Work Order ID 65746

Item Name: Dual Cargo Mirror Assembly

DART SERVICE INSTRUCTION

TO AMEND INSTALLATION INSTRUCTIONS D206-558 REV. C OR EARLIER
AND INSTRUCTIONS FOR CONTINUED AIRWORTHINESS ICA-D206-558 REV. 0

Figure 3: - View C: Looking Down on Mirror Installation
(D206-558-041 Mirror Shown)

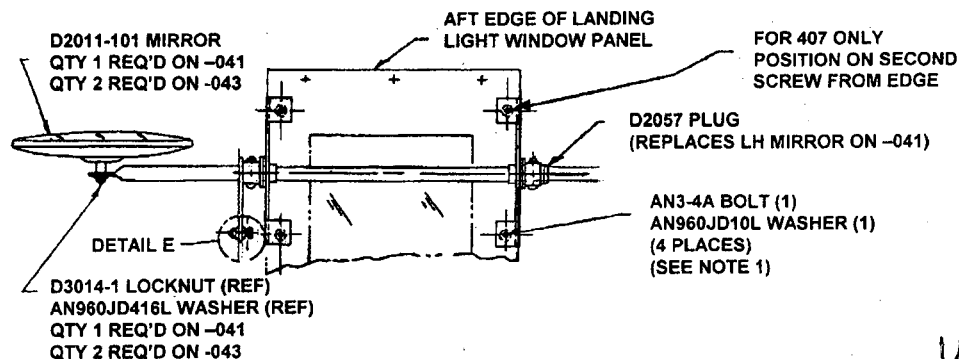
IT HAS COME TO DART'S ATTENTION THAT A LONGER CABLE IS REQUIRED WHEN INSTALLING THE DART D206-558-041/-043 SINGLE/DUAL CARGO MIRROR ASSEMBLY ON A BHT 407 AIRCRAFT. THIS IS DUE TO THE MIRROR INSTALLATION BEING MOVED FORWARD TO PICK UP ON EXISTING SET OF SCREW HOLES ON THE BELLY OF THE AIRCRAFT AS SHOWN IN FIGURE 3 OF INSTALLATION INSTRUCTIONS D206-558 REV. C OR EARLIER.

IT IS ACCEPTABLE TO REPLACE THE D2071 CABLE ASSEMBLY WITH D2071-3 CABLE ASSEMBLY. FURTHERMORE, IT MAY BE NECESSARY TO REPLACE THE MS35489-9 GROMMET WITH MS35489-67 GROMMET TO ACCOMMODATE A POSSIBLE VARIANCE IN MATERIAL THICKNESS ON A BHT 407 AIRCRAFT AS OPPOSED TO A BHT 206 AIRCRAFT.

INSTALL THE D2071-3 CABLE ASSEMBLY AND MS35489-67 GROMMET PER INSTALLATION INSTRUCTIONS D206-558 REV. C OR EARLIER AND MAINTAIN PER ICA-D206-558 REV. 0.
